Conceptual Review Agenda

Monday, February 23, 2015

Time	Project Name	Applicant Info	Project Description	Planner
9:30	CSU - Parking Lot CDR150009	Fred Haberecht (970) 491-0162 fred.haberecht@colostate.edu	This is a request to construct a surface parking lot at 2400 Research Blvd. (parcel #'s 9723400906 and 9723300901). The parking lot will contain 1,077 parking stalls. The parking lot will have access points on Research Blvd., Centre Ave., and Gillette Dr. One parcel is located in the Employment (E) zone district while the other parcel is on CSU land. This project will be subject to Site Plan Advisory Review (SPAR).	Jason Holland

PROJECT DEVELOPMENT AND UTILITY PLANS FOR RESEARCH BLVD. PARKING LOT PROJECT #14-031

Conceptual Site Plan

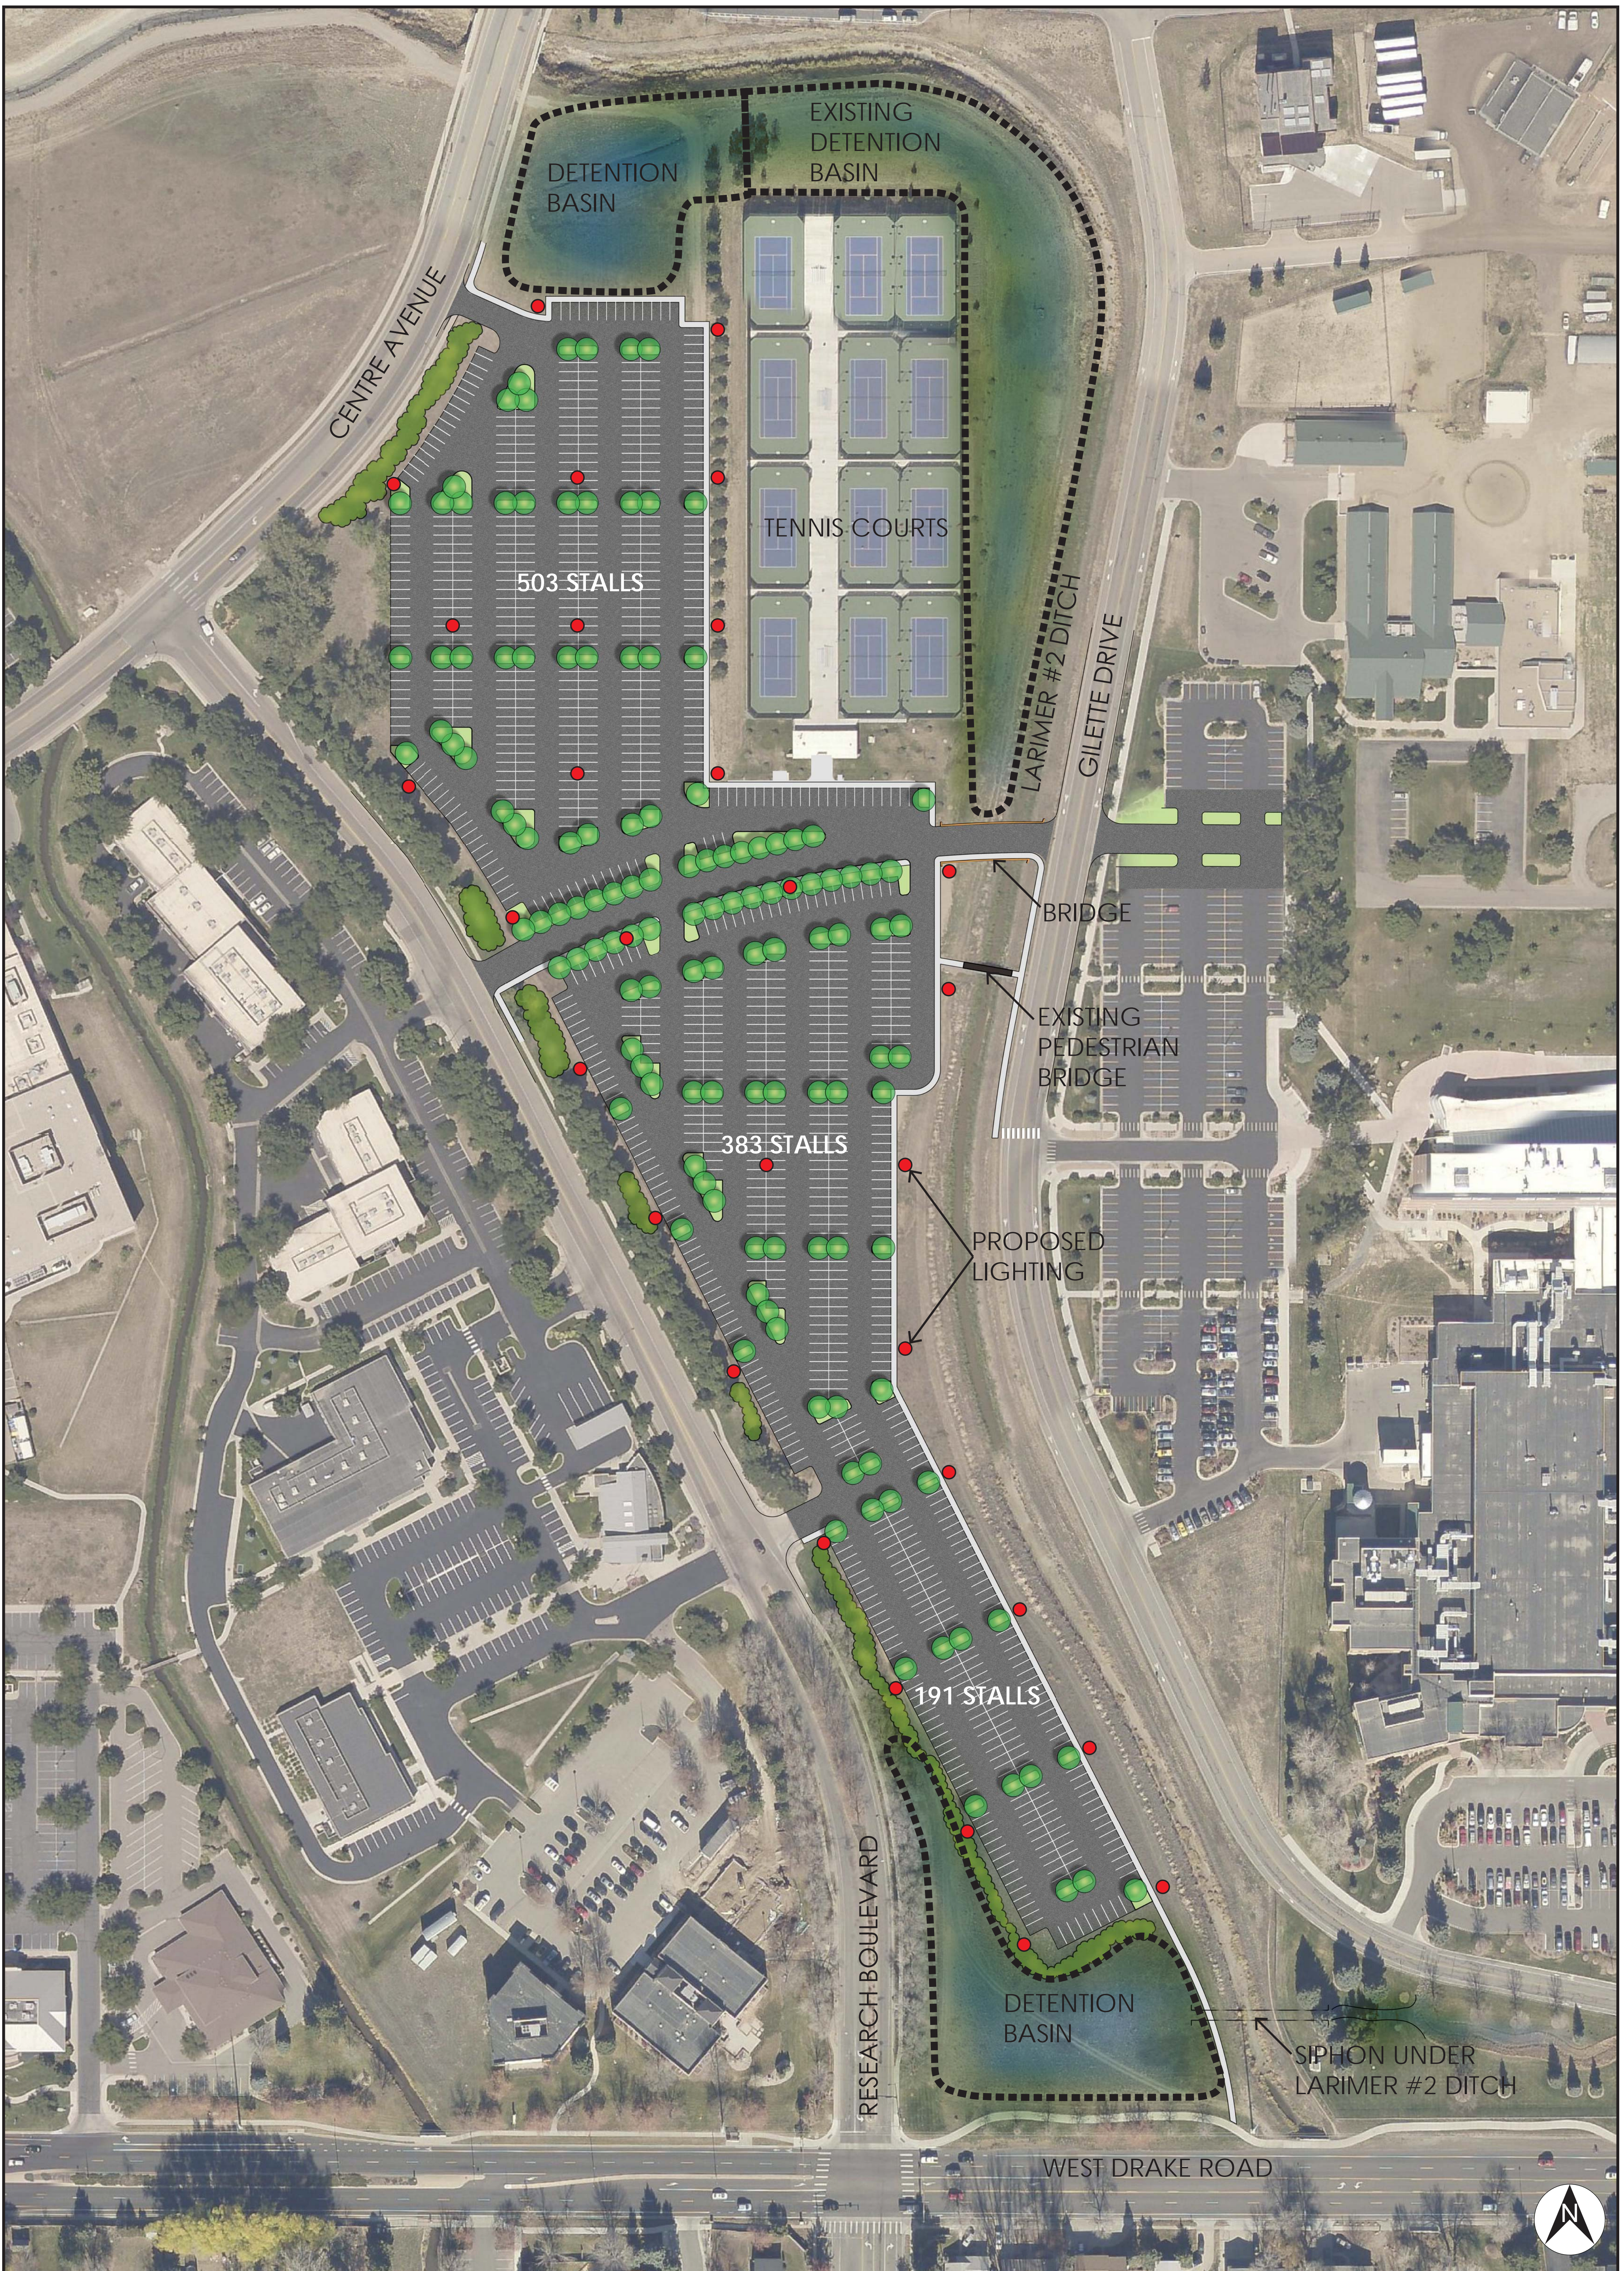
10. A Development Construction Permit (DCP) will need to be obtained prior to starting any work within the right-of-way.
11. LCUASS parking setbacks (Figure 19-6) apply and will need to be followed depending on parking design. Right now everything shown will meet this standard.
